PROJECT:  
**STAGE 5 - CLUB EXTENSION  
PHASE 2 WORKS - SOUTHERN  
CARPARK & ENCLOSURE**

DRAWING TITLE:  
**SITE ANALYSIS PLAN**

SCALE	DATE
As indicated @ B1	MARCH 2018
DRAWN BY: MC	CHECKED BY: DOC
PROJECT NO: 2341.06	DRAWING NO: DA-0001
CAD FILE:	ISSUE: 2

**SECTION 96**

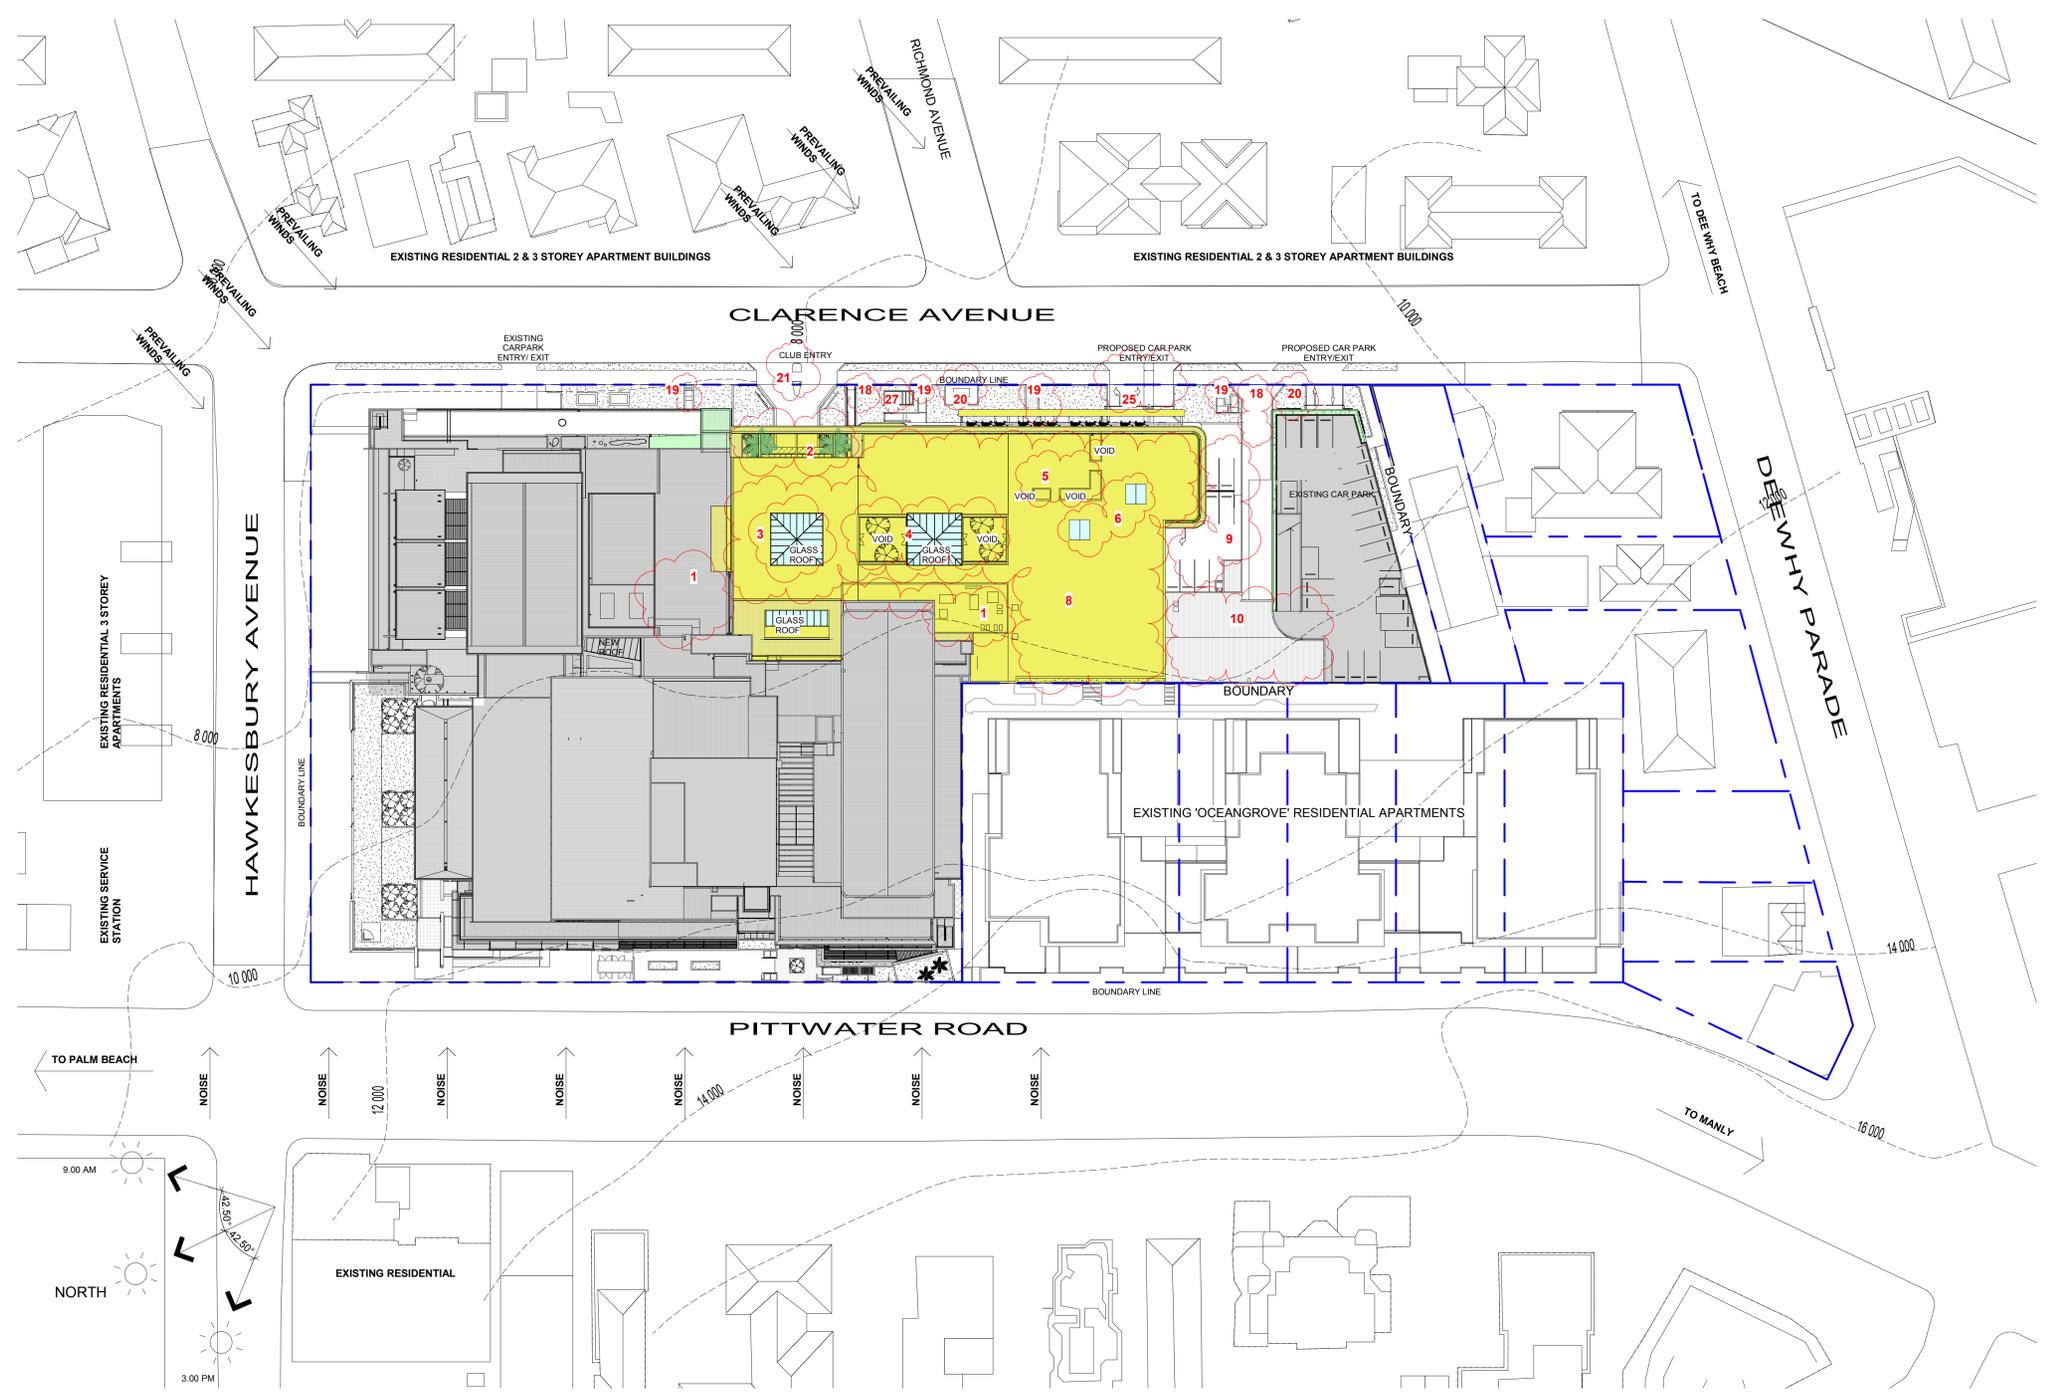
- CHANGES FOR SECTION 96 APPROVAL**
- roof
1. RELOCATED OPEN PLANTROOM AT THE ROOF LEVEL
  2. MODIFIED ROOF OPENINGS ABOVE MAIN ENTRANCE
  3. MODIFIED CENTRAL SKYLIGHT (REDUCED HEIGHT, MODIFIED PITCH)
  4. MODIFIED COURTYARD: TWO OPEN COURTYARDS AND ONE SKYLIGHT COVERED AREA INSTEAD OF ONE LARGE GLASS ROOF. REDUCED HEIGHT AND PITCH
  5. MODIFIED SMOKING TERRACE: ROOF OPENING, SIZE AND PLANTED AREA. AREA REDUCED BY 21m²
  6. REDUCED NUMBER OF ROOF SKYLIGHTS ABOVE ASIAN RESTAURANT. 2 INSTEAD OF 6 TO SUIT THE NEW INTERNAL LAYOUT
  7. MODIFIED EXIT STAIR: POSITION, CONFIGURATION, METAL ROOF NO LONGER REQUIRED
  8. CONCRETE ROOF INSTEAD OF METAL DECK ROOF FOR THE MAJORITY OF THE BUILDING EXTENSION
  9. NO SLAB ABOVE THE EXPOSED CAR PARK LEVEL 2 IN THE SOUTH AREA
  10. NEW ACOUSTIC METAL ROOF ABOVE REVISED LOADING DOCK

- facade
11. MODIFIED FACADE APPEARANCE DUE TO CHANGES IN THE CAR PARK LEVELS, LOADING DOCK AND EGRESS STAIRS
  12. REMOVED LOUVRES ON THE BACK FACADE (WESTERN FACADE) DUE TO MECHANICAL RISER NO LONGER REQUIRED / REVISED LOCATION FOR EGRESS DOORS
  13. 2m WIDE INTERNAL EGRESS STAIR MODIFIED INTO TWO 1m WIDE EXTERNAL STAIRS WITH DECORATIVE BALUSTRADES
  14. EXTENT OF LEVEL 2 (MAIN TRADING LEVEL) REDUCED BY 8328mm FROM THE SOUTHERN BOUNDARY AND INCREASED BY 1100mm TO THE EASTERN BOUNDARY
  15. MODIFIED FACADE CURTAIN WALL MULLION BLADES
  16. CONCRETE BLADE WALL REDUCED BY 1.47m IN HEIGHT AND 6.2m IN LENGTH
  17. VERTICAL FINIS REMOVED FROM BACK WALL (WESTERN FACADE)

- ground/landscape/floor plate
18. REVISED LOADING DOCK ENTRANCE AND LOCATION ENLARGED DEMOLISHED AREA IN THE EXISTING RETAINED SOUTHERN CAR PARK
  19. NEW / MODIFIED EGRESS PATHS FROM EXISTING CARPARK LEVEL -1. NEW CARPARK LEVEL 1.

20. RELOCATED ELECTRICAL SUBSTATION / LANDSCAPED AREA MOVED TO SUIT
  21. MEDIAN STRIP ADDED AT ENTRY TO PROVIDE PLACE OF REFUGE AND ENSURE WIDTH OF ENTRY/EXIT IS LESS THAN 8M AS PER DA CONDITION 23

22. RELOCATED STORMWATER OVERFLOW PATH
  23. EXTENT OF BASEMENT CAR PARK LEVELS REDUCED. BASEMENT REDUCED BY 14394mm FROM THE WEST BOUNDARY. BASEMENT ENLARGED BY 280mm TOWARDS THE SOUTH BOUNDARY. CARPARK CHANGED FROM FLAT PLATE TO SPLIT LEVEL ON ALL LEVELS. DEPTH OF CAR PARK INCREASED FROM RL -3.800 TO RL -5.700. OVERALL PARKING SPACES REDUCED FROM 687 TO 680

24. BASEMENT CAR PARK LEVEL -5 ADDED
  25. CAR PARK ENTRY / EXIT MOVED TOWARD NORTH BY 3044mm
  26. PLANTER MODIFIED ON THE BACK (WESTERN) FACADE DUE TO REDUCTION OF THE MAIN TRADING FLOOR SLAB

27. LOCATION OF AIR INTAKE MODIFIED
  28. EXTENT OF RESTAURANT REDUCED BY 136m²
  29. CLUB ENTRANCE ACCESSIBLE RAMPS MODIFIED
  30. ONE ADDITIONAL EXISTING CAR PARK SPACE TO BE REMOVED FROM EXISTING NORTHERN CAR PARK

31. SOLID MASONRY WALL ADDED BETWEEN EXISTING ZONE D CAR PARK AND LOADING DOCK ACCESS.
